Minor revisions in the pre-assessment section are needed to provide more clarity on the analyses performed and the connection between text and figures. For example, the method used to account for replicated events should be more fully explained - it is not clear what the percentages used in Figure 2 represent. Specific comments are provided below, first for providing more clarity and second for figures and tables.

Figure 3b. flood occurrences of the top 20 HUC4 basins (HUC2 codes in bold), grouped by months.

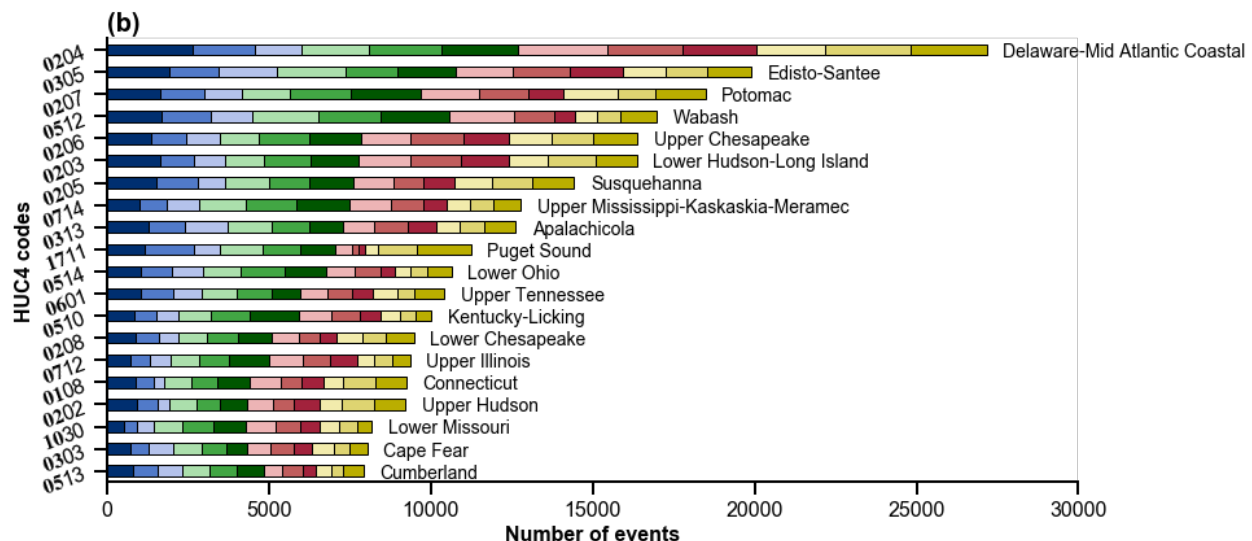
4. Line 226 “The Mid-Atlantic region – HUC3 02 – takes seven places out of the top twenty basins, with the Delaware river basin near the coast (HUC2-0204) being the highest one” – unclear what ‘top’ and ‘highest’ are referring to. If you are unfamiliar with HUC 2 and 4, it is difficult to connect this sentence to Figure 3. Bolding the ‘02’ portion of the HUC4 codes in Figure 3 could help, but ultimately it would be very helpful to have a mapping from codes to basin names.

Thanks for your suggestions. The text has been refined.

L.245 - “The Mid-Atlantic region – HUC2 02 – takes seven places out of the top twenty HUC4 basins listed in Figure 3b, with the Delaware river basin near the coast (HUC2-0204) being the highest one.”

We have made corresponding changes to the Figure 3b with HUC2 codes being bolded, and added basin names next to the bars.

Figure 3. (a) Map of months with largest flood occurrence in major U.S. watersheds (Hydrologic Unit Code 4). (b) flood occurrences of the top 20 HUC4 basins (HUC2 codes in bold), grouped by months.

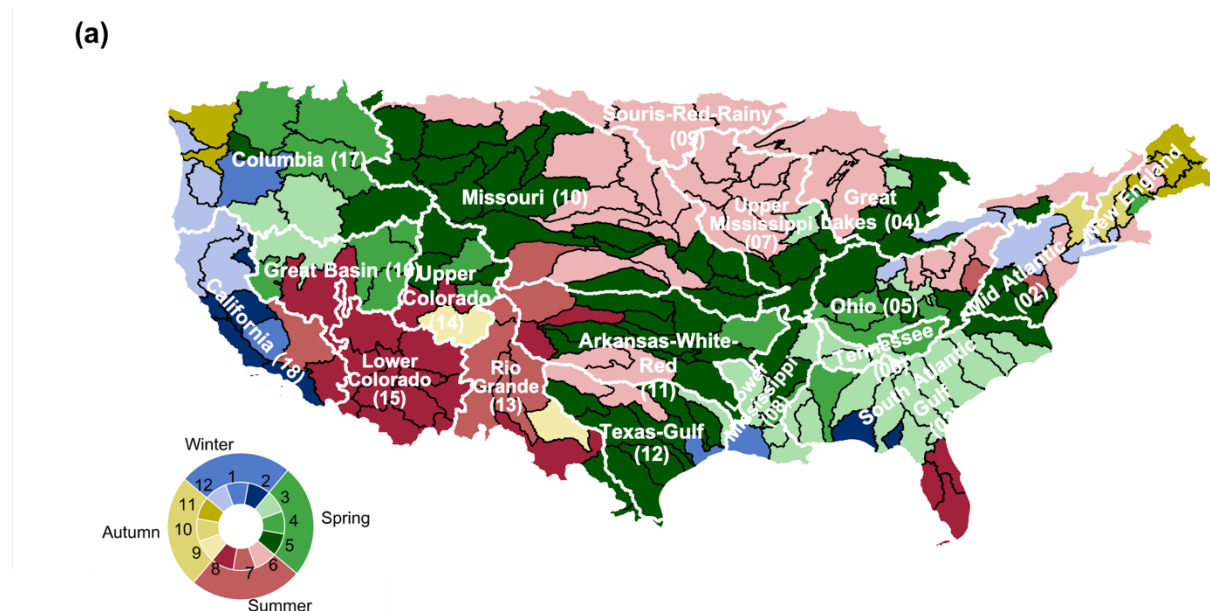
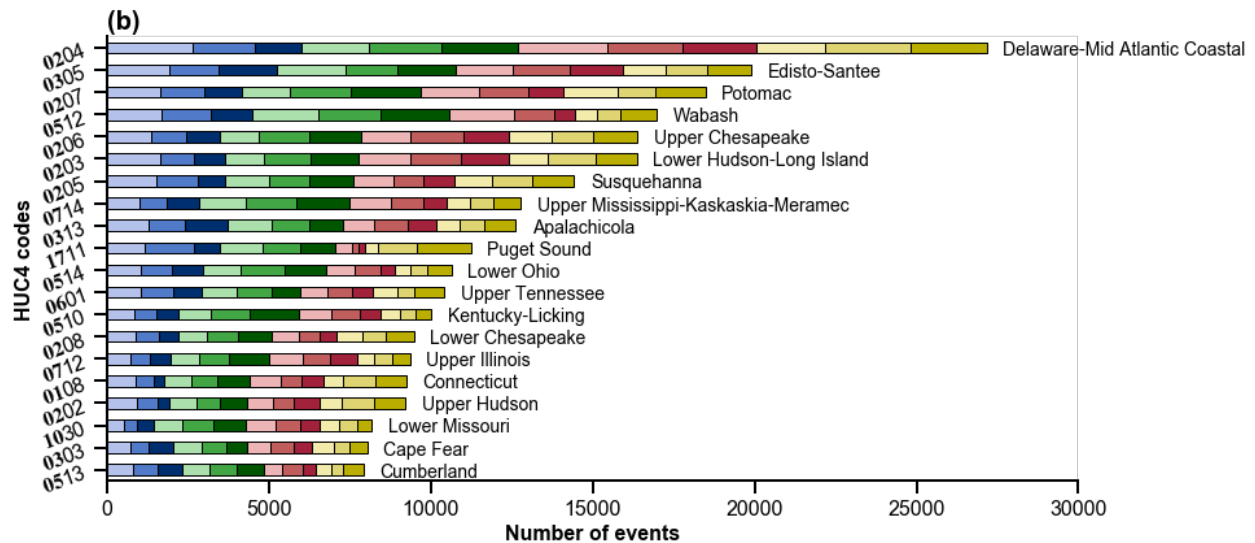
2. Figure 3 – provide a mapping from the HUC codes to the basin names used in the map.

4. Figure 3 and 4 - the wheel legend for coloring by month has increasing value in colors throughout each season except winter. It would be helpful to have the increasing value pattern consistent in all seasons.

Thanks for your suggestions, Figure 3 has been modified with HUC codes and names included.

Thanks for your suggestions, the two figures have been updated, as one is shown in comments #2 and the other one is shown below.
